**RE: INTERIM AUDIT ADVICE LETTER NO. 1 - GILLIESTON PUBLIC  
SCHOOL REDEVELOPMENT AND NEW PUBLIC PRESCHOOL SITE AUDIT -  
REVIEW OF RAP**

Ref: 318002140

Audit Number: TO-139

### Validation Sampling and Remediation Extents

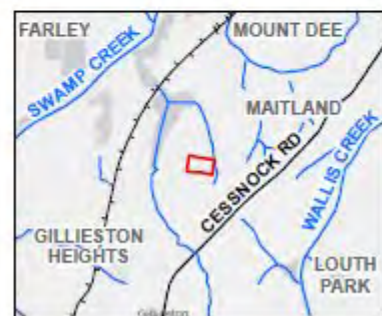
The CoPCs that require remediation have been summarised in **Table 4.1** based on the investigations and interim remediation previously completed by Stantec. The remedial extent is based on the current understanding, and as noted in **Section 4.1**, further investigation of data gaps is required following demolition or removal of the demountable buildings and hardstand pavements. Building D is understood to be heritage listed and will be retained as part of the redevelopment, and therefore no investigation or remediation of the building footprint is proposed.

Description	Extent of Remediation Required	Preferred Options
Lead and zinc impacted soil (remaining from interim remediation)	Lateral: 'Approximate Initial Remediation Extent' outside of the hatched area on Figure 3 in the RAP ( <b>Attachment 3</b> ). Approximately 115 m <sup>2</sup> around existing buildings in the northwest portion of the site. Vertical: Estimated to be 0.3 mbgl, depth of fill.	Excavation and Offsite Disposal, or Cap and Contain
Lead and zinc impacted soil (additional remediation area identified in DSI)	Lateral: 'Approximate Additional Areas Requiring Remediation' on Figure 3 of the RAP ( <b>Attachment 3</b> ). Approximately 197 m <sup>2</sup> around the interim remediation area and inferred to extend under buildings. Vertical: Estimated to be 0.4 mbgl, depth of fill.	Excavation and Offsite Disposal, or Cap and Contain
